Access Compliance Report

Public Rights-of-Way

(Curb Ramps)

Intersection ID: 51574	Main Street: RUSHING_CREEK_LN	Cross Street: WESLEY_VILLAGE_RD	Location:	N
ADA ID: 32EE27C16FBB	Ramp Type: Perp	Initial Pass/Fail: Fail	Overall Compliance: No	Severity Score: 8.75
Codes/Mitigation Info/Possible Solution		Field Measurements/Component Compliance

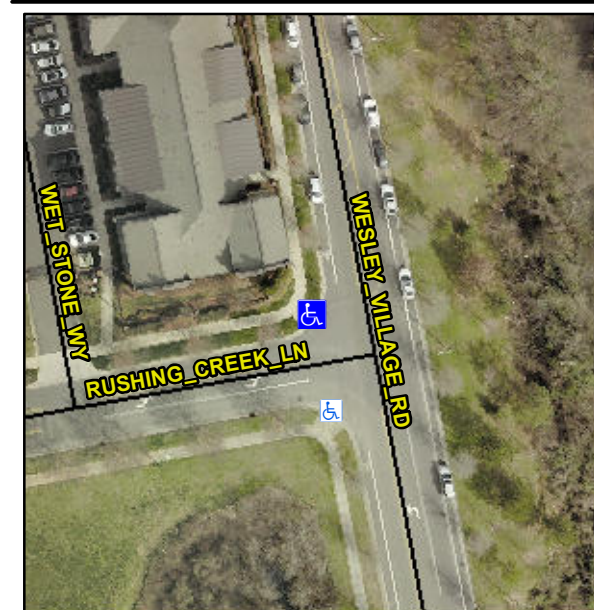
Not Found, R304.5.1

Compliance	Description	Data	Compliance	Description	Data
N/A	Ramp Length (in)	97.0	Yes	Ramp Slope (%)	5.1
No	Ramp Width (in)	41.0	Yes	Ramp XSlope (%)	2.0
N/A	Flare Type LT	N/A	N/A	Flare Type RT	N/A
N/A	Flare Slope LT (%)	N/A	N/A	Flare Slope RT (%)	N/A
N/A	Flare Traversable LT?	N/A	N/A	Flare Traversable RT?	N/A
N/A	Landing Length (in)	N/A	N/A	DWS Provided?	N/A
N/A	Landing Width (in)	N/A	N/A	DWS Contrast?	N/A
N/A	Landing Slope (%)	N/A	N/A	DWS Length (in)	N/A
N/A	Landing X Slope (%)	N/A	N/A	DWS Full Width?	N/A
N/A	Landing Curb? (Y/N)	N/A	N/A	DWS Offset (in)	N/A
N/A	Shared Landing?	N/A			
N/A	Gutter Ponding?	N/A	N/A	Gutter Slope (%)	N/A
N/A	Gutter Lip Ht (in)	N/A	N/A	Gutter X Slope (%)	N/A
N/A	Painted X Walk1?	No	N/A	Painted X Walk2?	N/A
	X Walk 1 Direction	To S		X Walk 2 Direction	N/A
N/A	X Walk 1 Width (in)	N/A	N/A	X Walk 2 Width (in)	N/A
	X Walk 1 Slope (%)	0.7		X Walk 2 Slope (%)	N/A
	X Walk 1 X Slope (%)	1.4		X Walk 2 X Slope (%)	N/A

Remove & Replace Entire Ramp.
